STAFF RECOMMENDATION
1517 Paris Avenue
May 15, 2013

Application: New construction – detached accessory dwelling unit
District: Belmont-Hillsboro Neighborhood Conservation Zoning Overlay
Council District: 18
Map and Parcel Number: 11704026900
Applicant: Van Pond, architect
Project Lead: Sean Alexander, sean.alexander@nashville.gov

Rear Addition at 1517 Paris Avenue. Dumpster on left is in approximate location of proposed DADU.

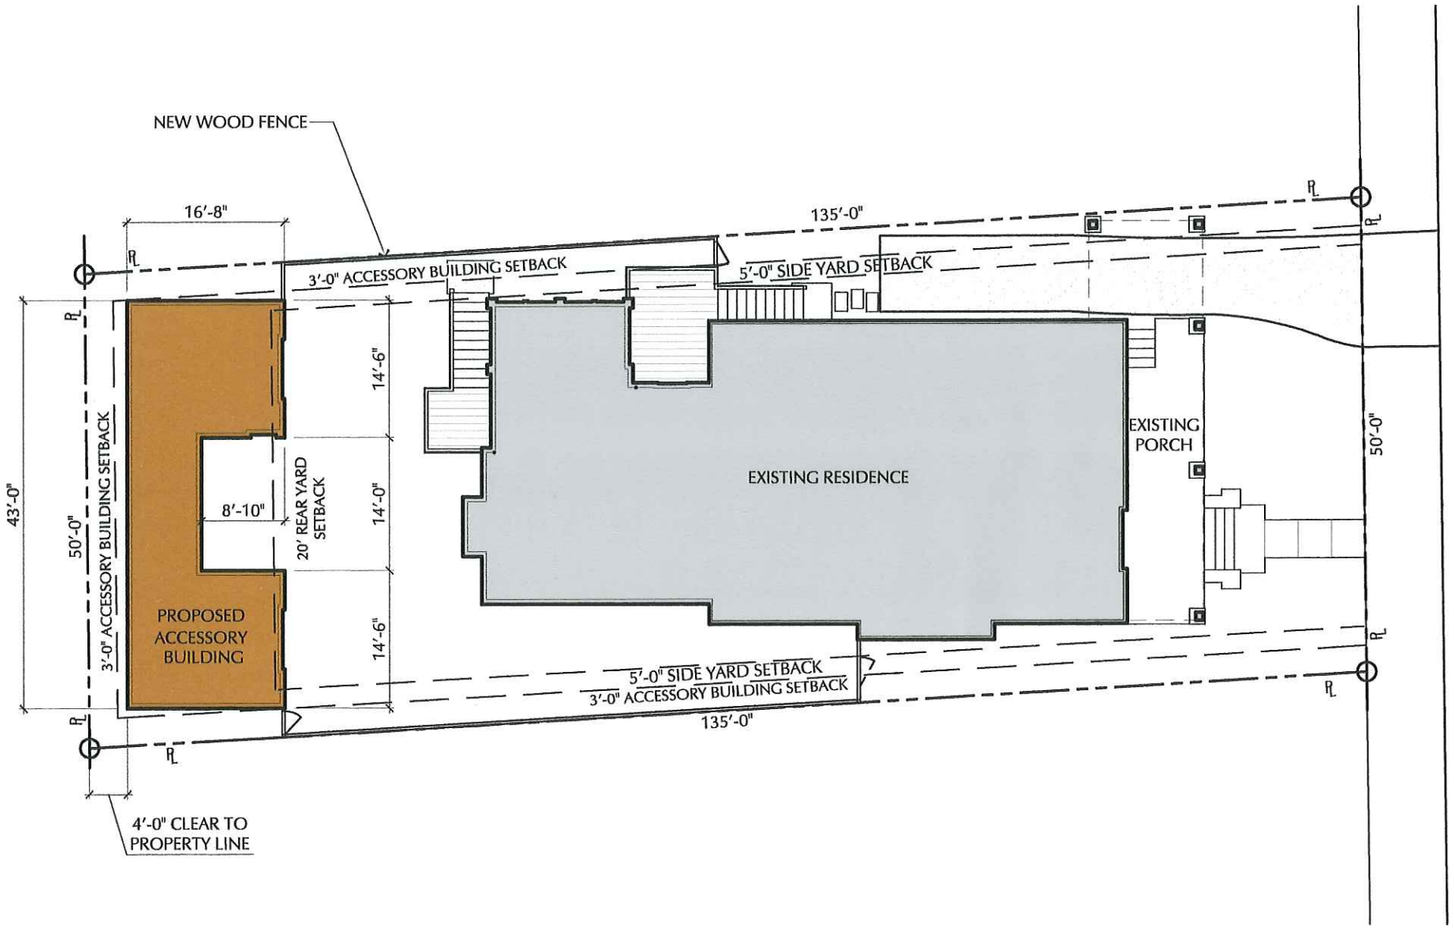
With the recently constructed two-story addition, the footprint of the primary building has a footprint size of two thousand, three hundred, ninety-seven square feet (2397 sq. ft.) leaving sixty-four percent (64%) of the lot remaining as open space. The DADU would bring the proportion of open space down to fifty-six percent (56%).

Location & Setbacks
The building is located at the rear of the lot as required by the design guidelines and the DADU standards. There is no vehicular access or associated parking. The building is setback more than the minimum of ten (10') from the primary house as required by the standards. The building will be at least three feet (3') from both side and rear property lines, which meets the bulk zoning setback requirements and is compatible with the location of historic accessory buildings. Staff finds the application to meet guideline II.B.1.c.

Proposed Site Plan

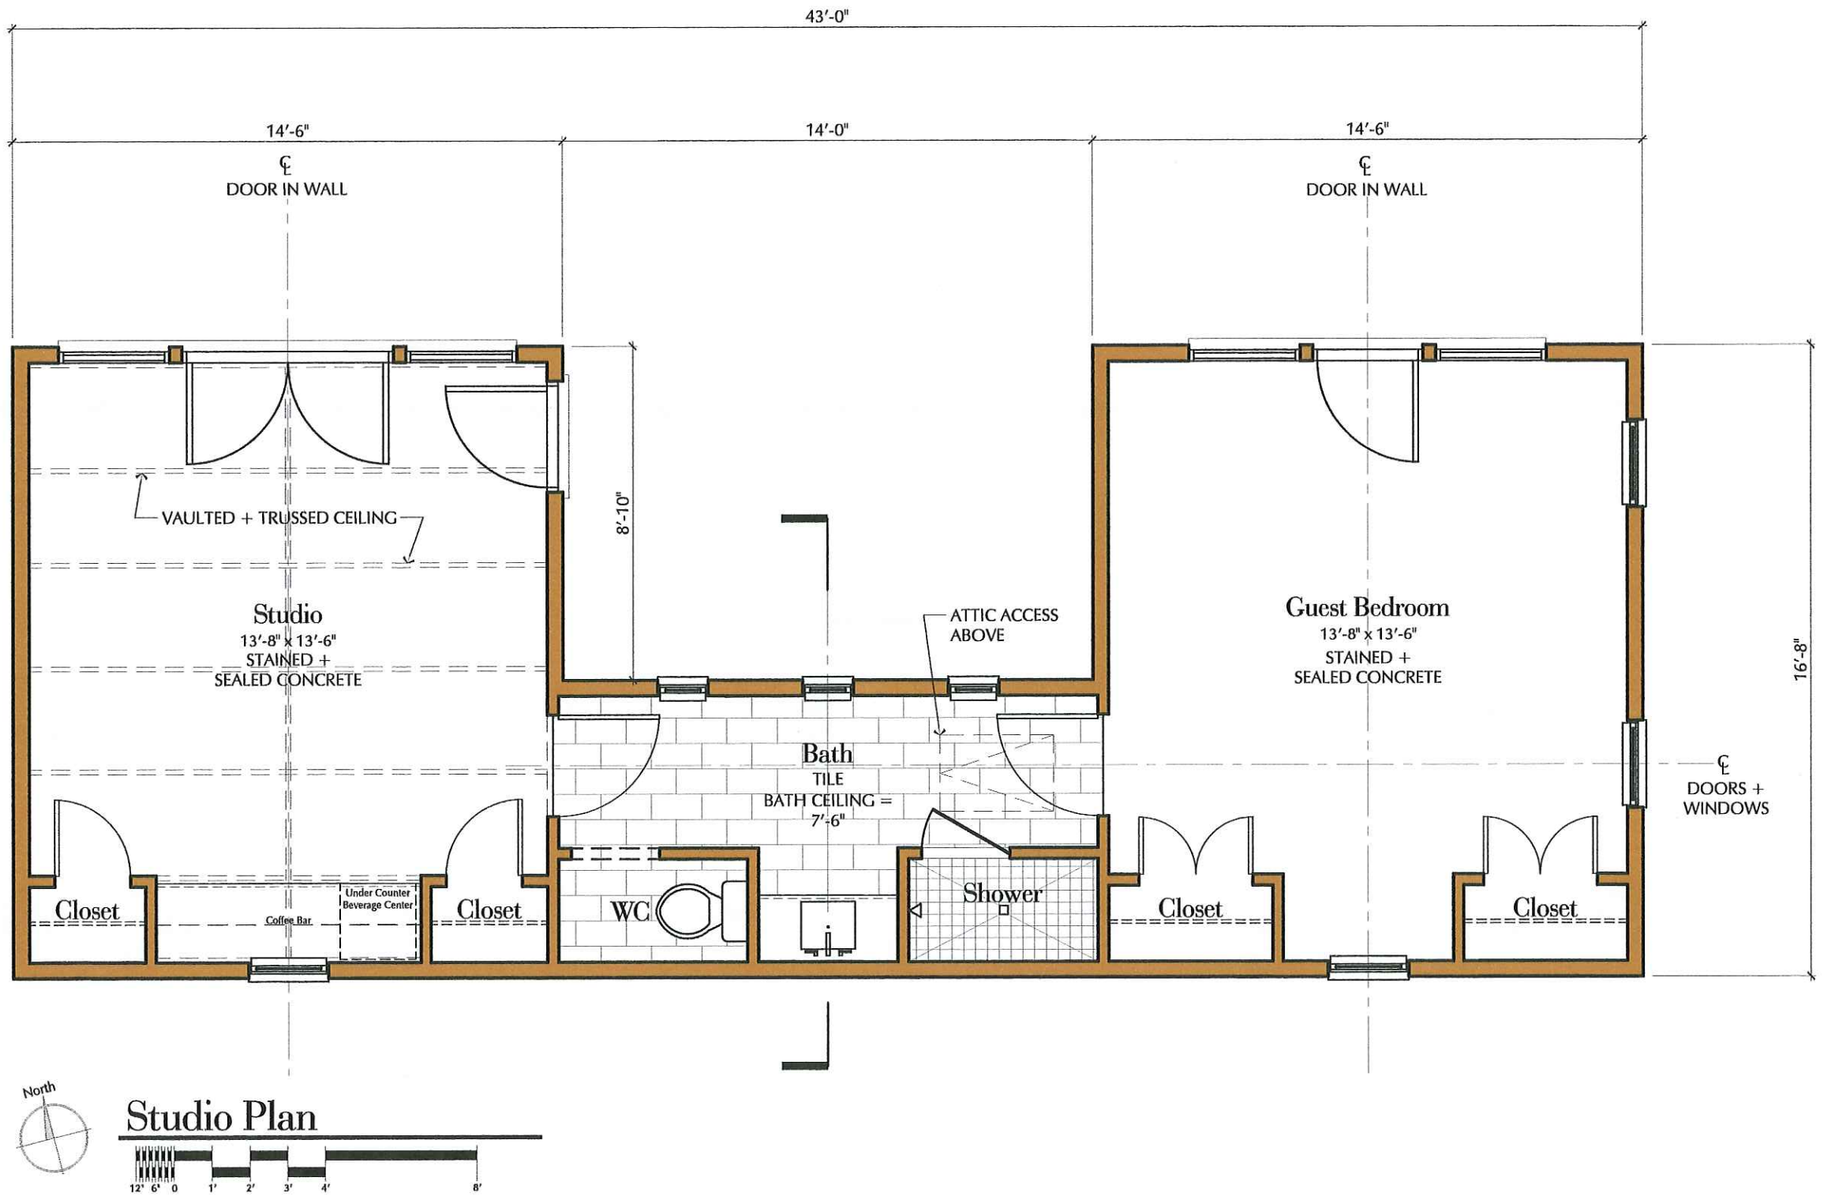
The floor plan of the building will be U-shaped, with a footprint size of five hundred, eighty seven square feet (587 sq. ft.), which is less than the required maximum of seven hundred square feet (700 sq. ft.).

Roof Plan

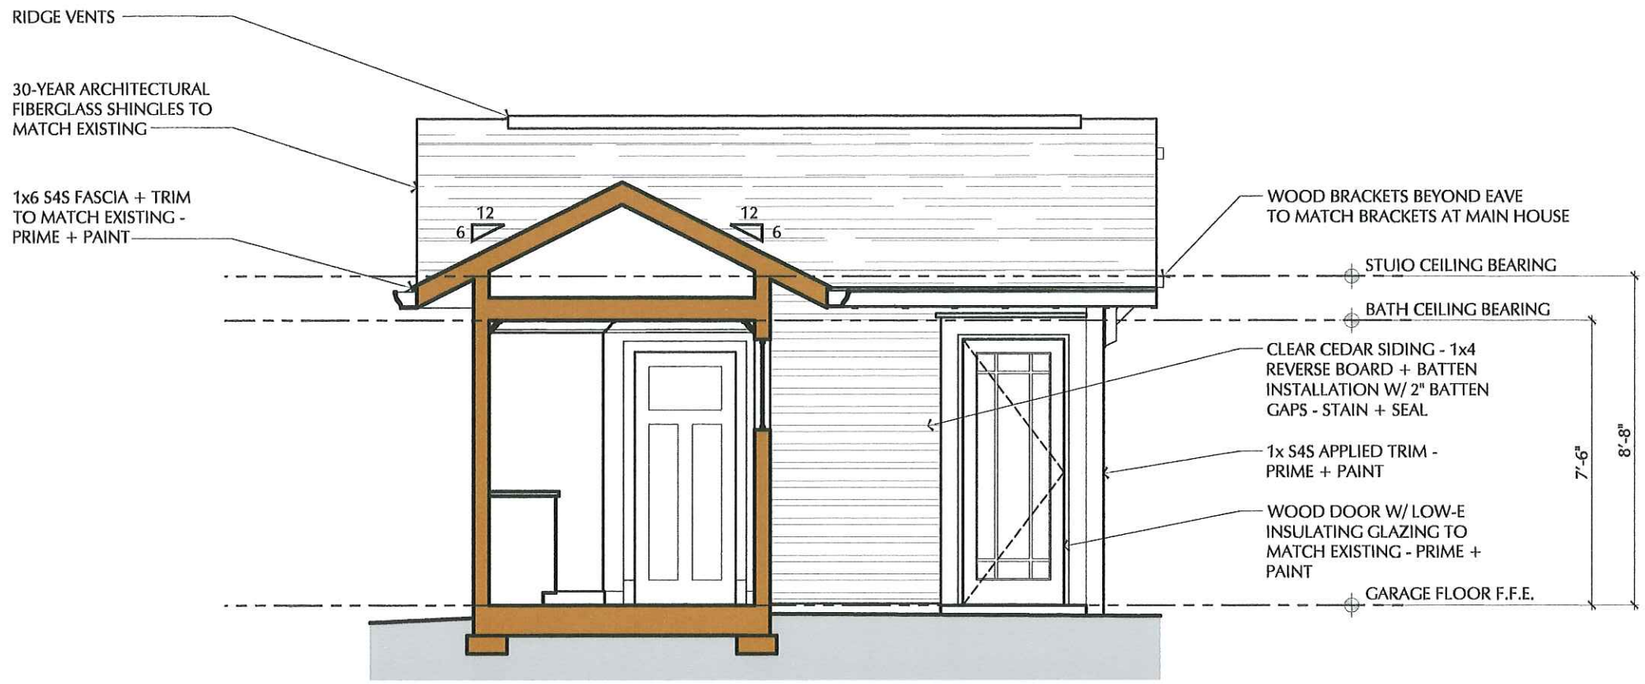
Roof Form
The roof of the new building would be U-shaped with two gables facing the house, and a lower "saddle" connecting them. The roofs will all have a 6:12 pitch. The roof forms are similar to that of the house, which has an 8:12 pitch primary gable and 6:12 front gabled dormer. Staff finds that the DADU roof would meet guideline II.B.1.e.

Front Elevation (North)

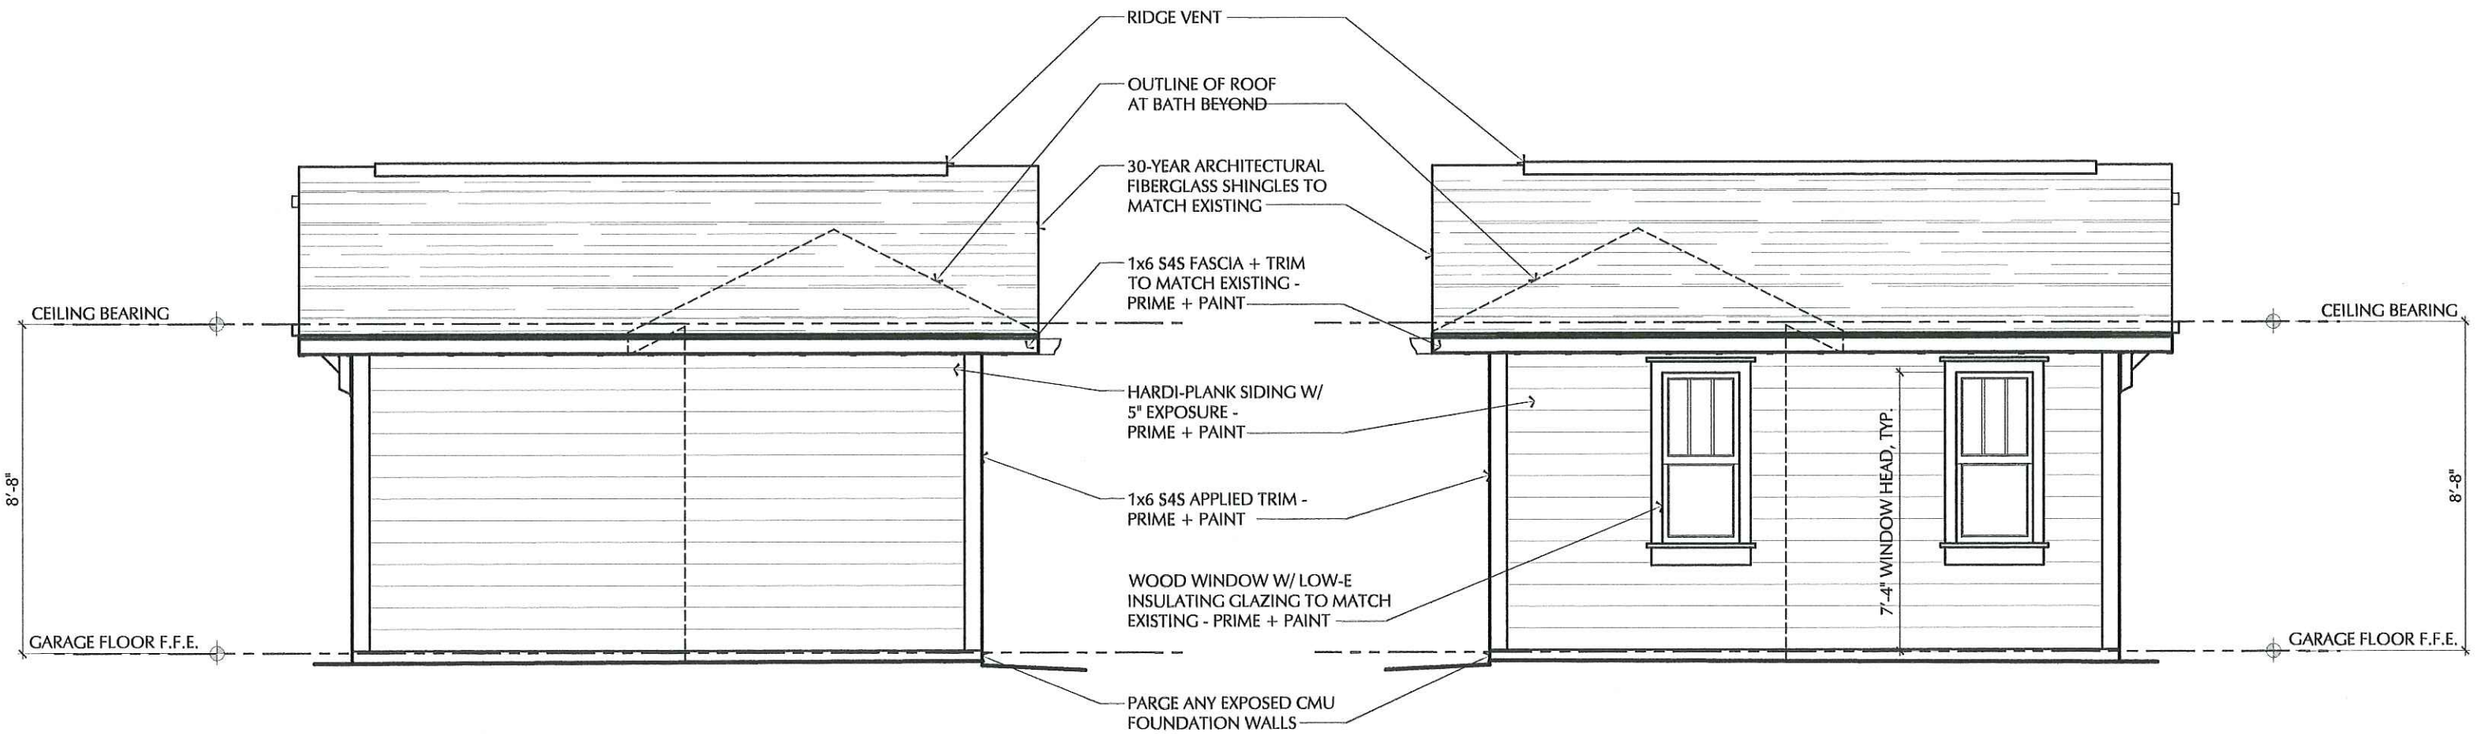
<u>Height, Scale</u>
The proposed DADU would be one story tall, with a ridge height of thirteen feet (13') and an eave height of eight feet (8'). These measurements are well under the required maximum eave height of ten feet (10') eaves and the eave height of the house, which varies from ten feet (10') to fourteen feet (14') with grade.

Orientation
The orientation of the new building will reflect that of the primary building.

Rear Elevation (South)

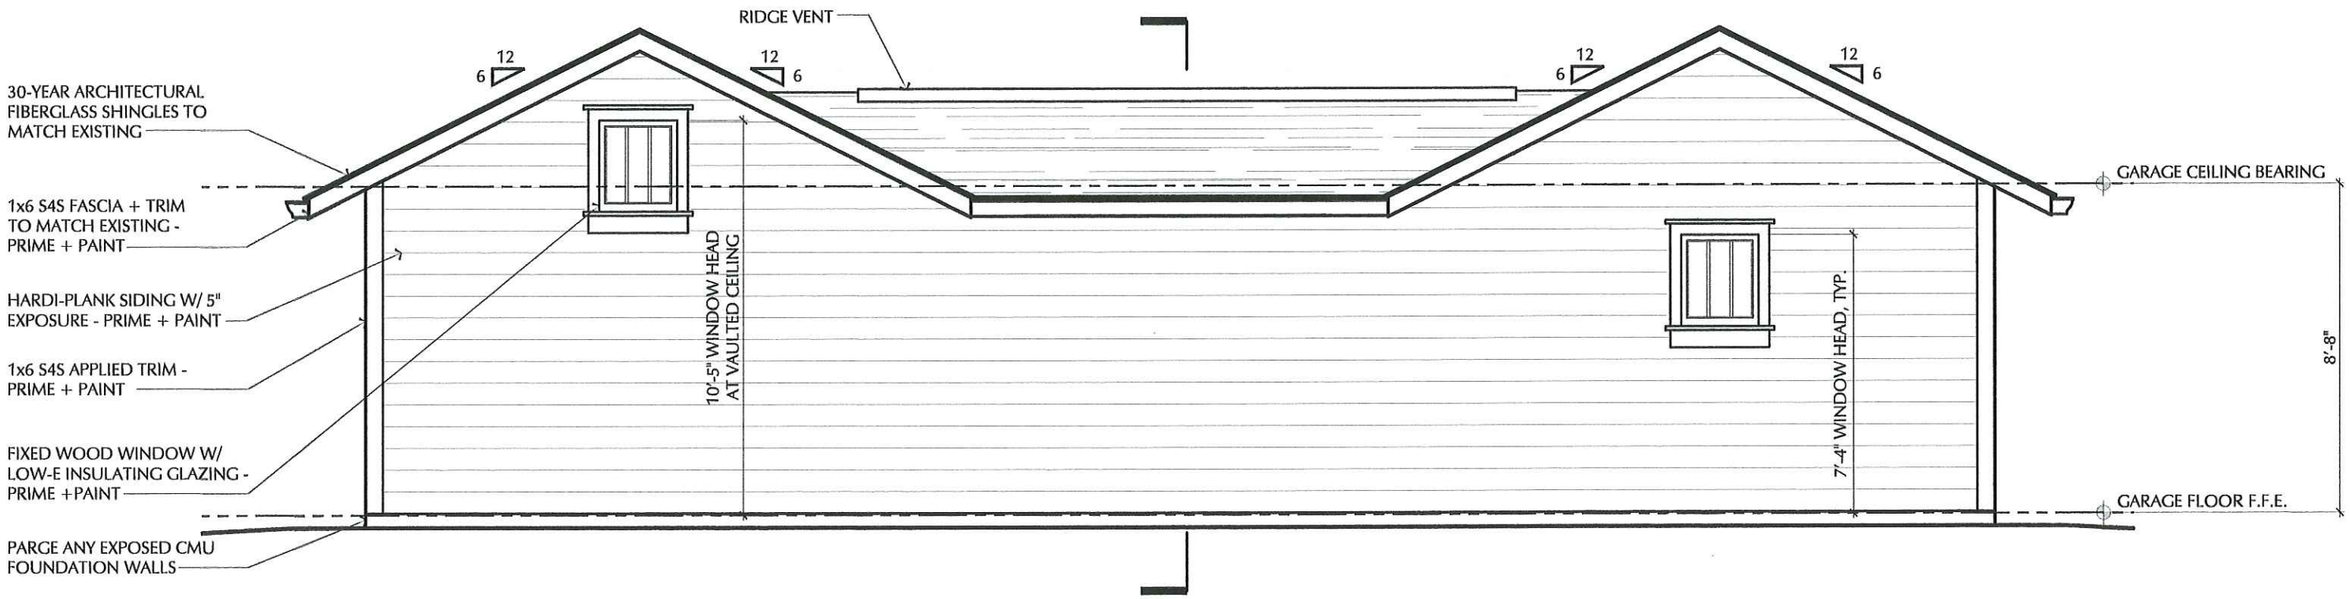
Proportion and Rhythm of Openings
The proportion of the majority of the windows and their placement is similar to what is found on the house with the exception of the rear elevation facing the alley. Typically, the commission has been more lenient about window requirements on outbuildings when they are located at the rear of the lot.
